## MILOS GEOTHERMAL DEVELOPMENT

Consultant's Field Report

**MILOS GEOTHERMAL DEVELOPMENT**

**Report NO: OS-89008**

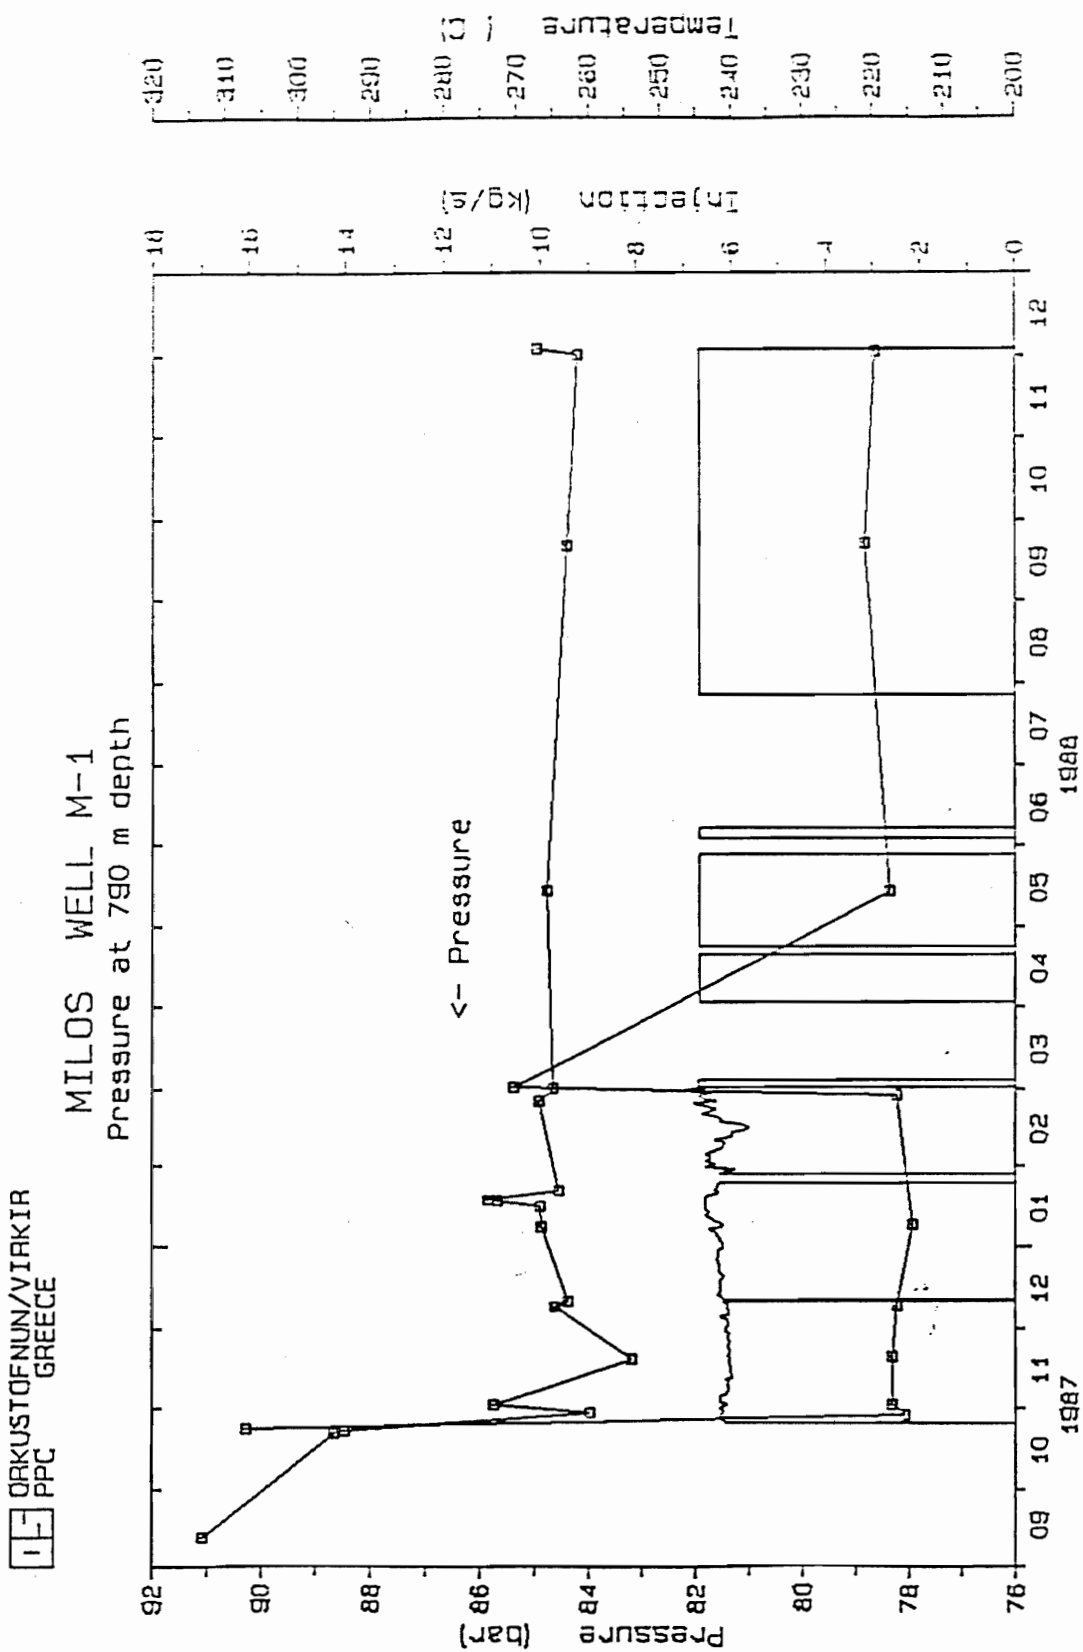
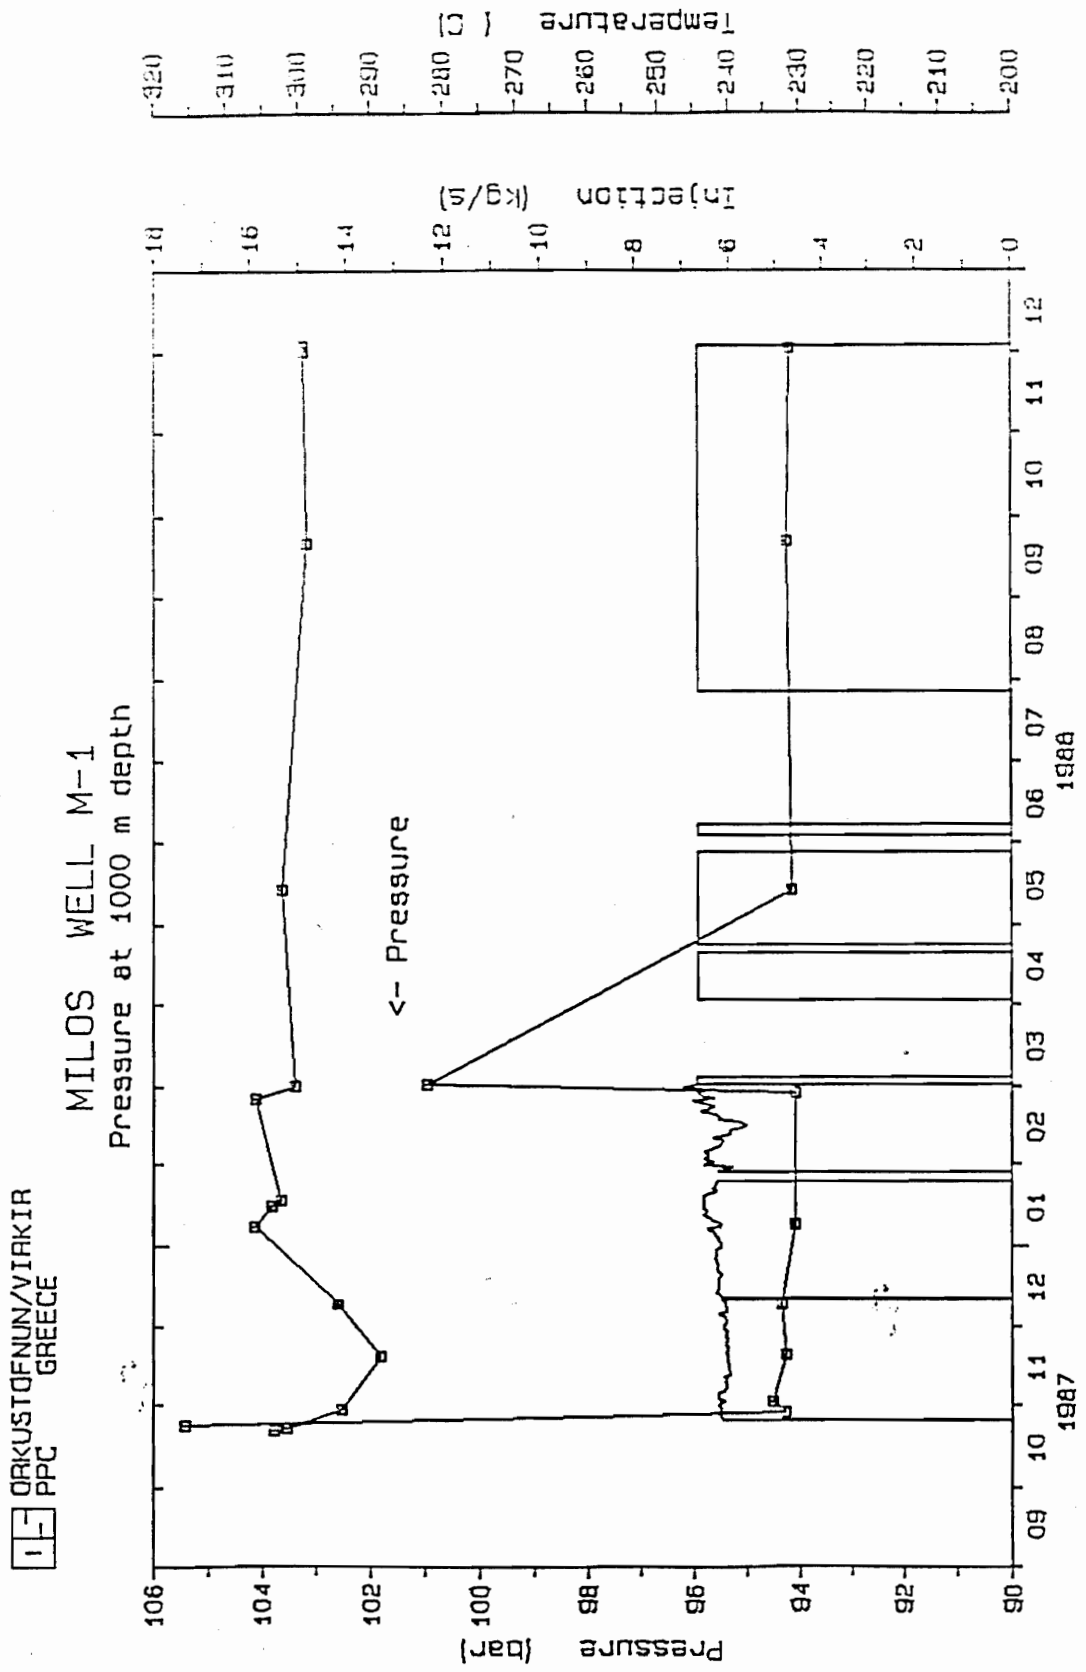
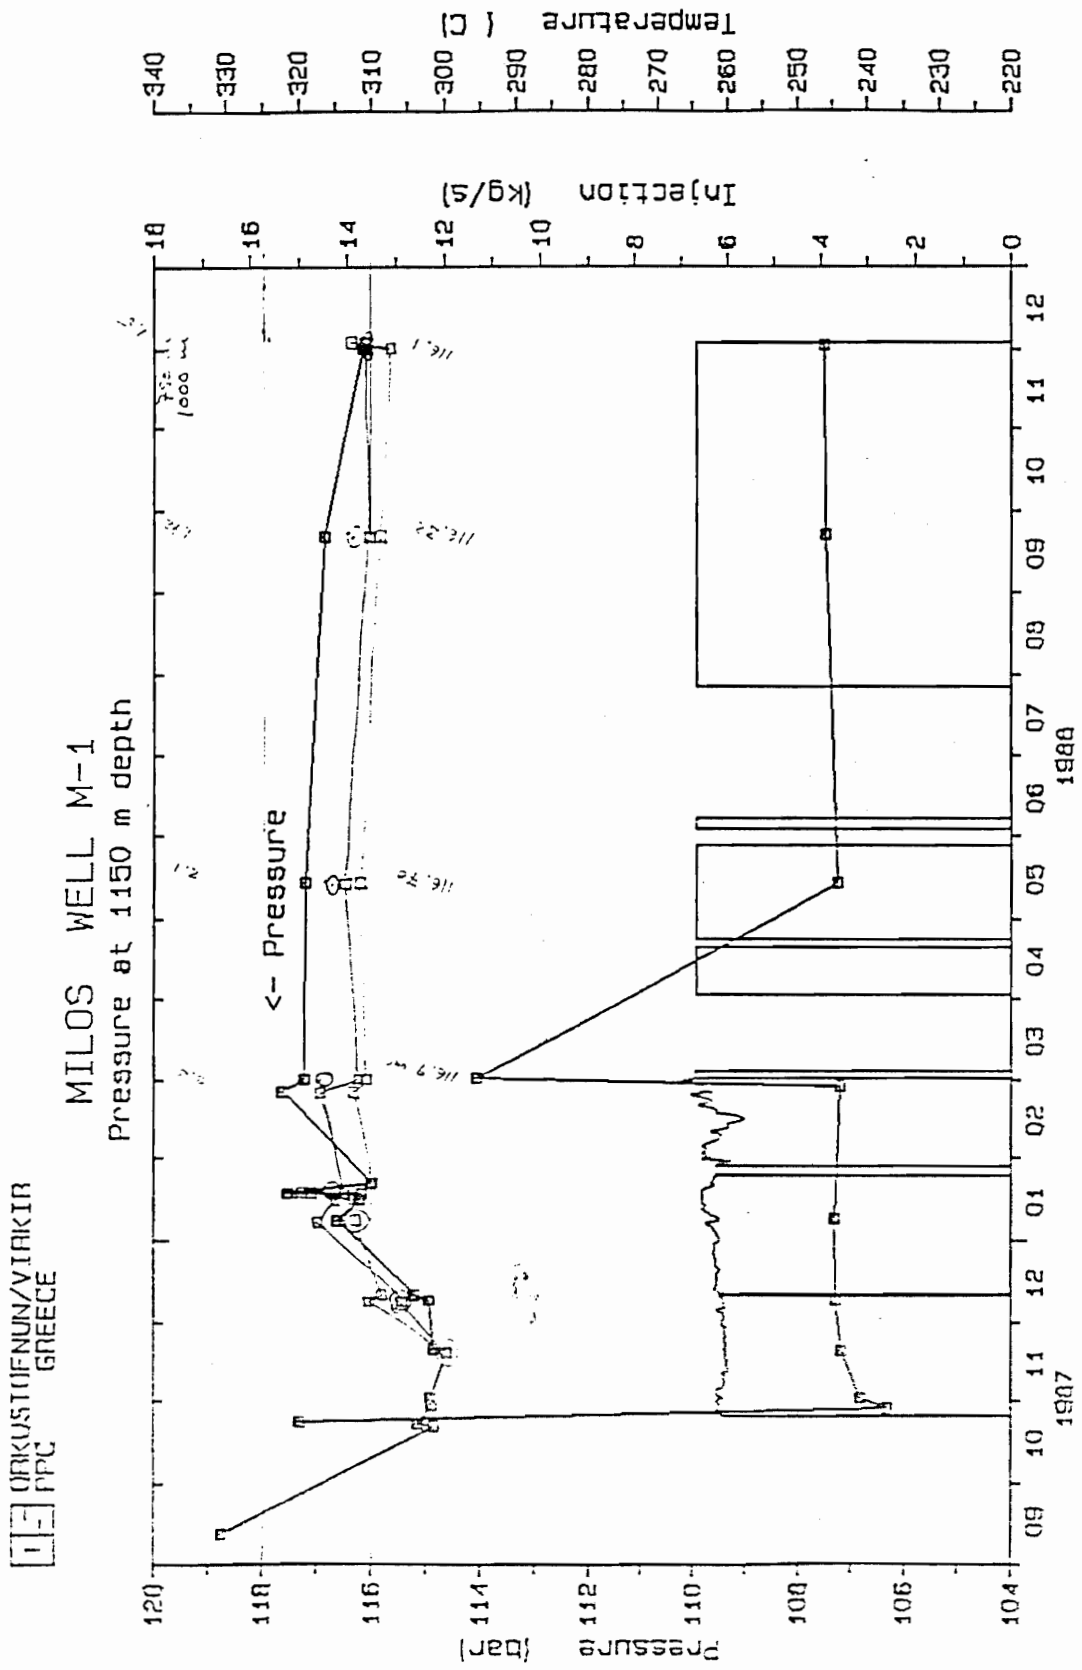
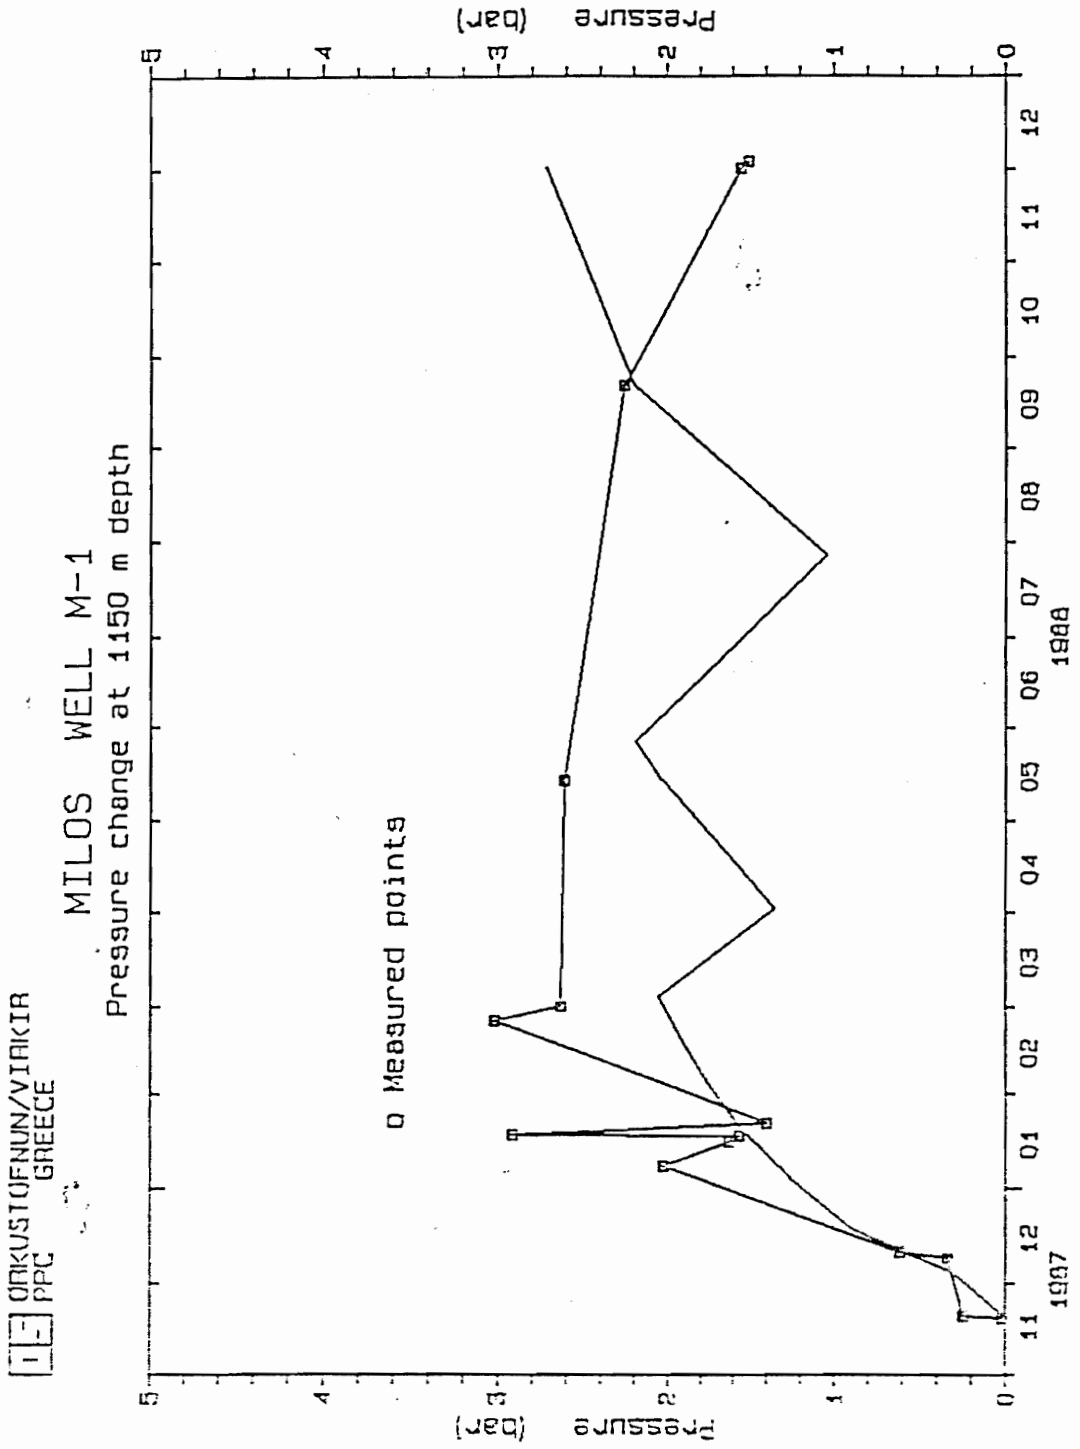
The analytical model was nevertheless checked against the additional data using the same parameters as earlier. An adequate match is obtained between measured (smoothed) and calculated pressure values until June 1988. At that date, the reinjection was interrupted for nearly two months. After injection was restarted in late July, the model predicts higher pressure increase in well M-1 than is actually measured. Possible reasons could be, that the model fails as stated earlier, the reinjection rate is less after July than it was before, or the injectivity of well M-1 has improved from earlier conditions during this last period. Further data and possibly numerical simulation is required to distinguish between these possibilities.
